AMENDMENTS TO THE DRAWINGS:

REMARKS

I. Objection to the Drawings

Fig. 5

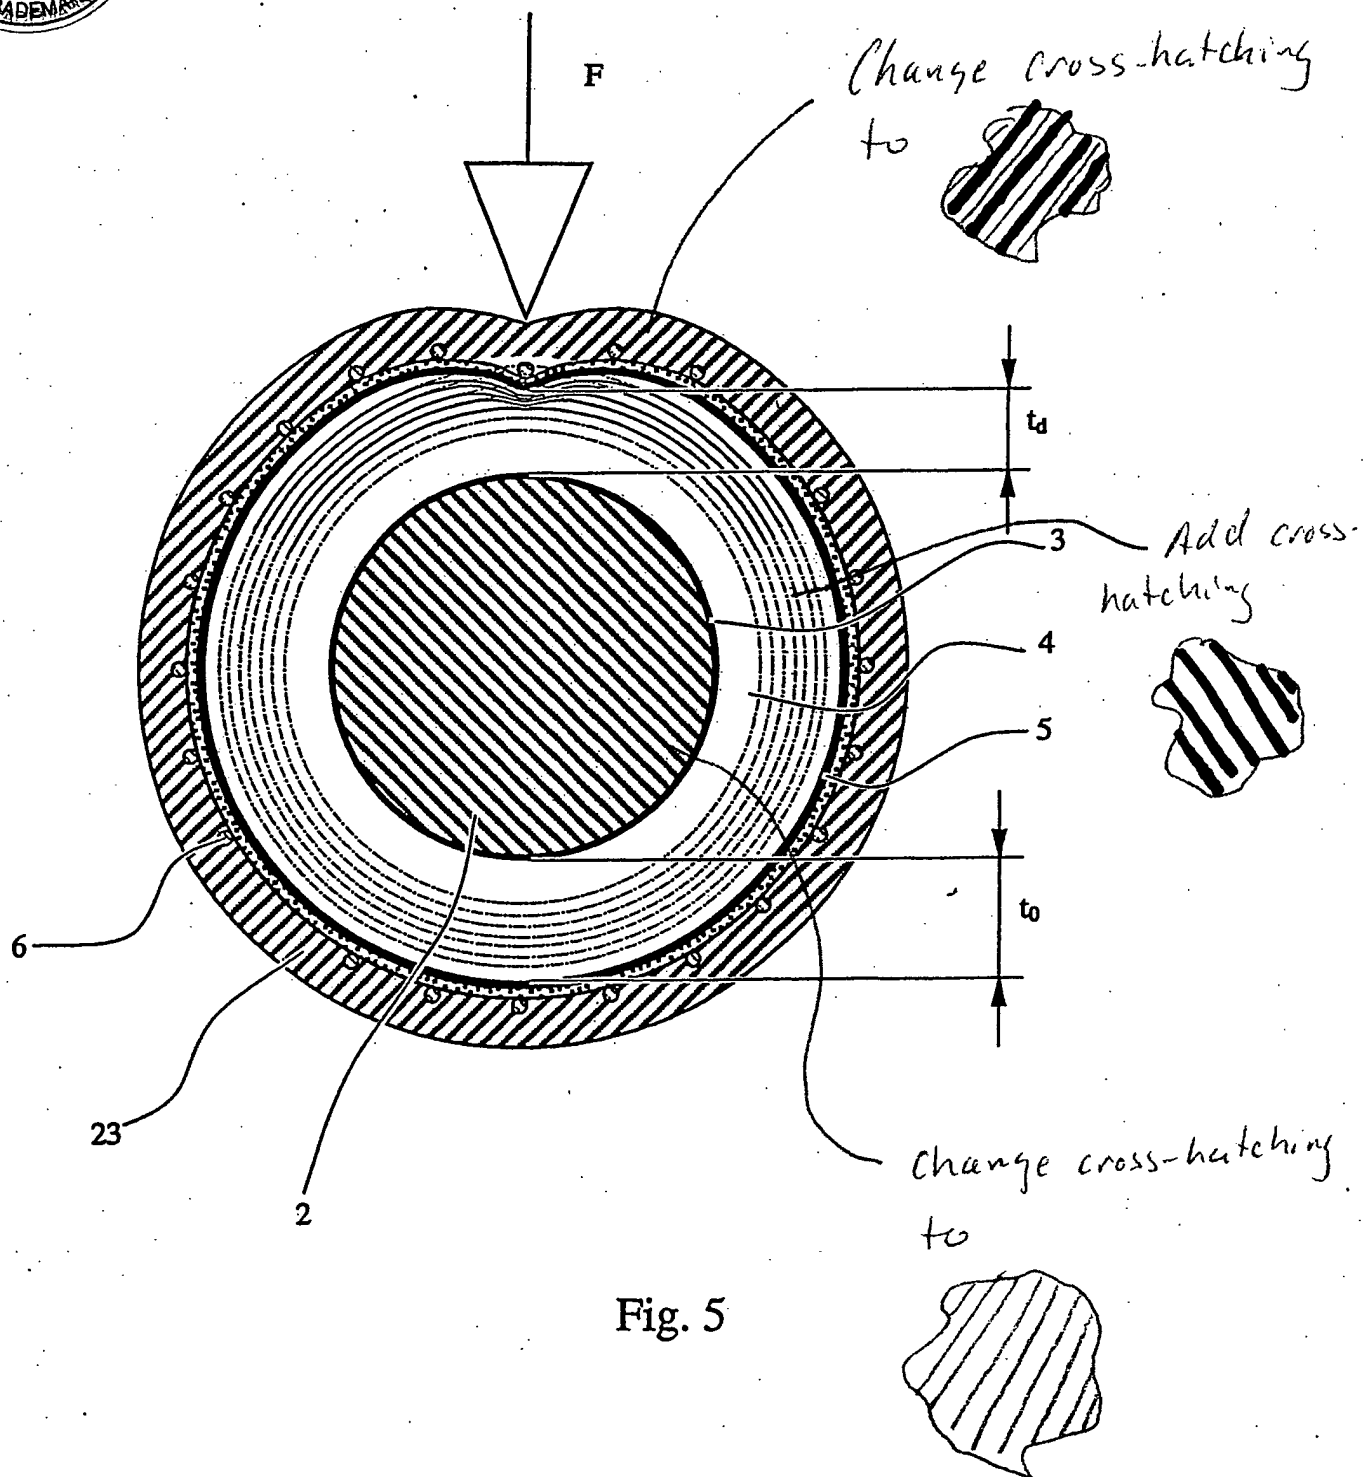
The drawings were objected to "because Figures 5-6 lack[] the proper cross-hatching which indicates the type of materials, which may be in an invention. Office Action at 2. Applicants have amended Figs. 5 and 6, such that those drawing figures comply with the symbol requirements of M.P.E.P. § 608.02. Applicants respectfully submit that the claims should not be interpreted based on inferences relating to the cross-hatching symbols designated in M.P.E.P. § 608.02 and added to Figs. 5 and 6, which show exemplary embodiments. Rather, the claims should be interpreted based on the broadest reasonable interpretation consistent with U.S. practice of the terminology recited in the claims themselves. Applicants respectfully request reconsideration and withdrawal of the objection to the drawings.

Please amend the drawing figures as indicated on the two Annotated Sheets attached to this Amendment, which are marked-up copies of the drawing sheets containing Figs. 5 and 6. As indicated in the Annotated Sheets, Applicants have amended Figs. 5 and 6, such that those drawing figures comply with the symbol requirements of M.P.E.P. § 608.02. Applicants have also attached two Replacement Sheets, which incorporate the changes shown on the two Annotated Sheets.
